# UNITED STATES PATENT AND TRADEMARK OFFICE

FILING DATE FIRST NAMED INVENTOR ATTORNEY DOCKET NO. CONFIRMATION NO. APPLICATION NO. 05/17/2001 James M. Gust GRD0122.CIP 4110 09/859,718 EXAMINER 03/02/2004 Todd T. Taylor PATEL, DHIRUBHAI R TAYLOR & AUST, P.C. ART UNIT PAPER NUMBER 142 S. Main St. P.O. Box 560 2831 Avilla, IN 46710

#### Part III DETAILED ACTION

# SKETCH "A"

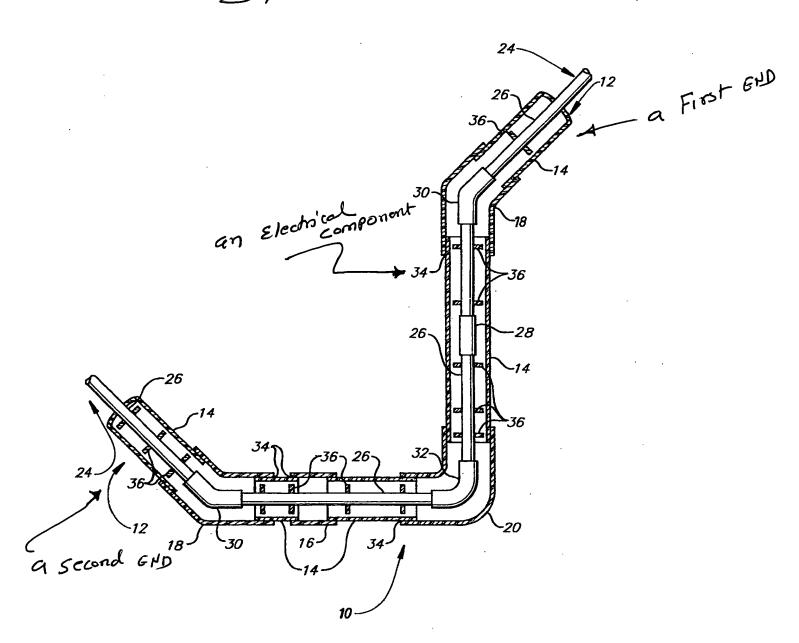
Regarding claim 1, at least one electrical conductor 24 (see fig 1, column 4 lines 65-67), a

flexible electrical tubing 12 having a first end and a second end (see sketch A), said tubing

loosely carrying said at least one electrical conductor (see fig 1); said at least one electrical

conductor traversing said tubing from said first end to said second end (see sketch A)and an

electrical component 34 associated with said at least one electrical conductor (see fig 1), said

electrical component solely hermetically sealing said first end (see sketch A, column 5 lines

24-35).
